MODIFICATION.REAR BRAKE EQUALISER.

MODEL BENTLEY MARK VI

M O D I F I C A T I O N .

ALTERATION TO BRAKE LINKAGE ADJUSTMENT

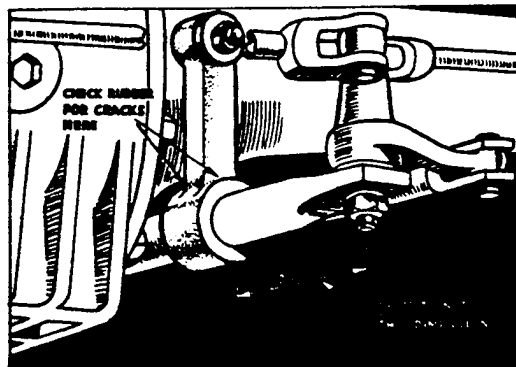
A certain number of cars were built with the rubber support of the rear brake equaliser fitted and positioned whilst in the chassis stage of production. When the body is mounted, the effect of its weight on the geometry of the rear suspension causes distortion of the support which may lead to fracture; repositioning of the support is therefore necessary in some cases.

Examination for signs of fracture, and if necessary, repositioning on the equaliser bar should be carried out on Bentley VI cars as follows:-

B-AK and B-AJ Series. Chassis Nos.....All cars.

B-BH Series. Chassis Nos.....Up to No.B220BH on cars fitted with Standard saloon body.

Chassis Nos.....Up to No.B138BH on cars fitted with custom built body.

1. Disconnect the rubber support from the axle tube and flex it backwards and forwards so as to examine for cracks in the neck at the junction with the main boss. If there are any signs of cracks, replace with a new support.
2. Check that the rear face of the main boss is 2.275 ins. from the centre of the rear brake equaliser bolt, and reposition if necessary.
3. Paint the letter 'E' on the rear face halfway down the rubber leg after examination and repositioning.

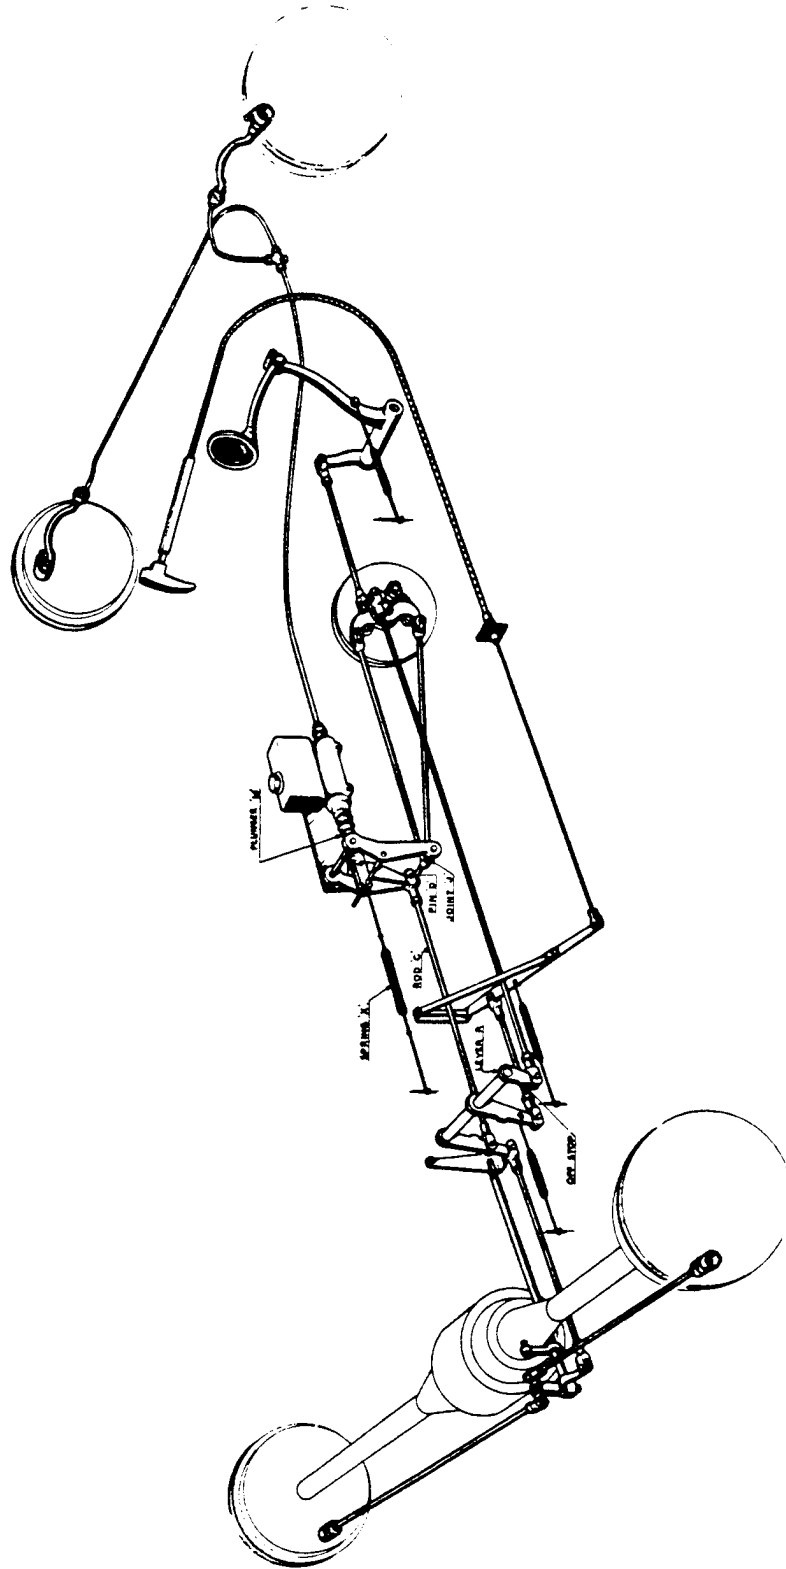
A modification is introduced to reduce a mechanical noise that can more accurately be described as a "clonk" from the brake linkage which may occur on application of the brakes.

In many cases, the origin of this noise has been traced to excessive free travel between the plunger and piston of the brake master cylinder, and adjustment of the brake linkage as described hereunder, has in certain instances effected a noticeable reduction of the noise.

1. Ensure that the rear brakes are in the OFF position and that the lever 'R' is against its OFF stop.
2. Remove the master cylinder pull-off spring 'X' and the clevis pin 'D'
3. Adjust the rod 'C' so that the joint 'J' has zero to .050" free travel before the plunger 'M' contacts the master cylinder piston.
4. Tighten the locknut on the rod 'C'. Replace the clevis pin 'D' and the master cylinder pull-off spring 'X'.
